Contract #: 04-0120F4Cty: SF/ALA Rte: 80 PM: 13.2/13.9File #: 69.25B**QUALITY ASSURANCE -- NON-CONFORMANCE REPORT****Location:** Changxing Island, Shanghai, P.R. China**Report No:** NCR-000471**Prime Contractor:** American Bridge/Fluor Enterprises, a JV**Date:** 07-Oct-2009**Submitting Contractor:** Zhenhua Port Machinery Company, Ltd (ZPMC), Changxing Island**NCR #:** ZPMC-0444**Type of problem:**

Job Name: SAS Superstructure

Subject: NCR No. ZPMC-0444

REGARDING: NCR-000389/437/471/474/476/483 (ZPMC-0363/411/444/447/449/456)

Component: Side Panel Segment Splice at 1AAW to 1AW

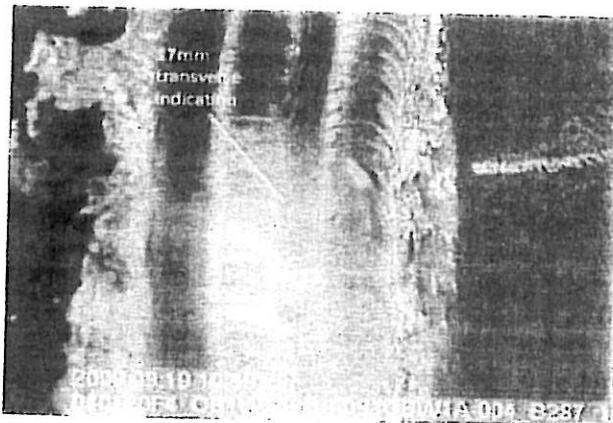
The Quality Assurance (QA) Inspector observed on Sept 18, 2009 and Sept 19, 2009 three (3) visual Transverse Linear Indications in the repair gouges of weld OBW1A-004 (1AAW to 1AW Side Panel Splice at the crossbeam side). The indications were located and documented at Y locations of 5842mm, 6165mm and 6520mm respectively. These visual Transverse Indications were measured from the weld of the Bottom Panel to Side Panel progressing toward the Edge Panel. Subsequently, ZPMC QC performed MT and confirmed that these are transverse indications. This weld joint had been previously tested and accepted by ZPMC QC NDT department.

3) "In addition to the provisions in AWS D1.5, Section 3.7.4 and Section 12.17, all repairs of cracks require prior approval of the Engineer."

AWS D1.5 (02) Section 6.26.1.1 "The weld shall have no cracks"

Propose a resolution for the identified recurring non-conformance which constitutes a systematic problem on both materials/workmanship and quality control issues with revised procedures to remedy the defected work and to prevent future occurrences. A response for the resolution of this issue is expected within 14 days.

Component: 1AW to 1BW Weld #OBW1A-007

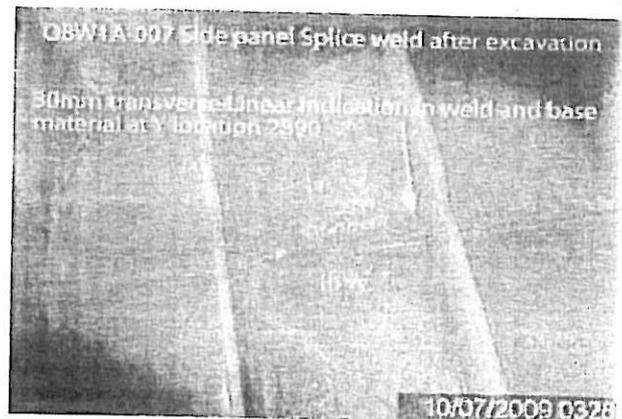
During a random visual observation of ZPMC personnel performing air carbon arc gouging of segment 1AW to 1BW Side Panel transverse splice weld OBW1A-007 at the Counterweight side, the Caltrans Quality Assurance (QA) inspector observed ZPMC was performing this repair utilizing the weld repair report (B-WR8086). This weld repair report did not describe any magnetic particle testing (MT) verifications in the excavation prior to re-welding nor after the completion of welding to ensure that the joint is free of defects. The QA Inspector had the opportunity to perform MT after air carbon arc gouging and observed numerous transverse cracks present ranging from 2 mm to 30 mm in length. No Critical Weld Repair Report was obtained for this weld repair.

The Y locations and the number of Transverse Cracks observed in weld # OBW1A-007:

- 1) Y=50~2475mm, (14) Transverse Cracks
- 2) Y=2720~5030mm, (29) Transverse Cracks

AWS D1.5-2002 Section 3.7.2.4 Crack in Weld or Base Metal; The extent of the crack shall be ascertained by the use of MT, PT, or other equally positive means; the metal shall be removed for the full length of the crack plus 50mm [2"] beyond the end of each crack and re-welded.

Submit a repair procedure to the engineer for approval. Include MT procedure using a competent MT technician.

Component: 1AAW to 1AW Deck Panel Weld Splice OBW1-001

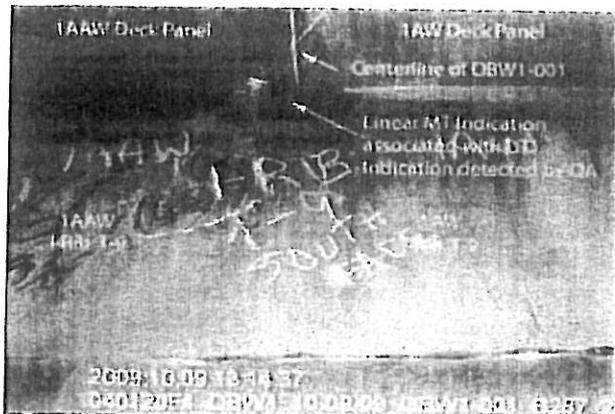
The QA inspector discovered one (1) class "A" rejectable Longitudinal Linear indication in the OBW1-001 (deck panel) weld. This weld was previously tested and accepted by the contractor. This acceptance by the contractor is evident by the presence of the contractor's distinguishing mark indicating QC acceptance. The QA inspector was also able to verify this UT longitudinal indication by magnetic particle (MT) testing from the interior side of the splice weld.

NOTE: The Y location of the Class "A" rejectable Longitudinal Linear Crack is at 5310-5340mm measured from Point W1, or 19750-19780mm if measured from W6. This indication is identified as #25 on ZPMC UT Report B787-UT-8548-1 associated with B-WR7867. The QA inspector verified a 40mm Magnetic Particle (MT) Linear Crack from the interior surface that is associated with Class "A" UT" Rejectable Indication mentioned above.

AWS D1.5-02 Section 6.26.3.1 "Welds that are subject to UT in addition to visual inspection shall be acceptable if they meet the following requirements:

Submit a repair procedure to the engineer for approval.

Component: 1AW to 1AAW Side Panel Splice Weld OBW1A-00

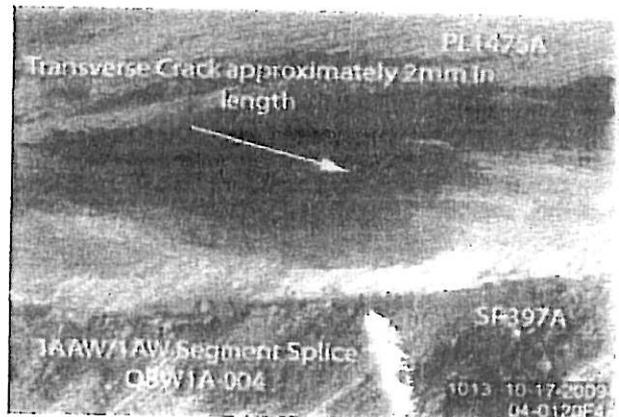
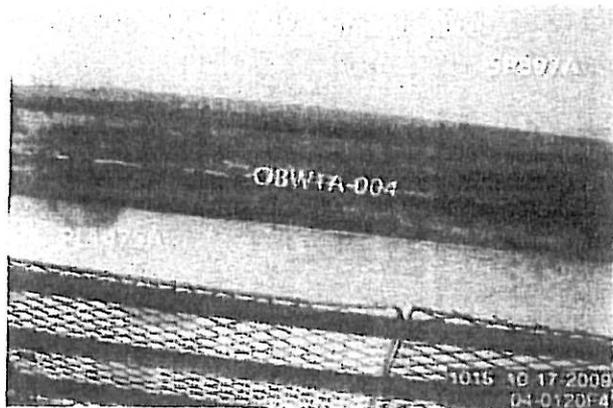
During random visual inspection the QA Inspector performed Magnetic Particle Testing (MT) of an Ultrasonic Testing (UT) reject excavation in the segment CJP Side Plate splice (OBW1A-004), cross beam side joining SP397A (1AW) and PL1475A (1AAW). During this verification the QA Inspector discovered three (3) Transverse Cracks in the excavation. One (1) 2 mm crack was located at Y location 1945mm and two (2) 1mm cracks at Y location 2785mm from the cross beam side Edge Plate.

AWS D1.5-2002 Section 3,7,2,4 Crack in Weld or Base Metal; The extent of the crack shall be ascertained by the use of MT, PT, or other equally positive means; the metal shall be removed for the full length of the crack plus 50mm [2"] beyond the end of each crack and re-welded.

Submit a repair procedure to the engineer for approval.
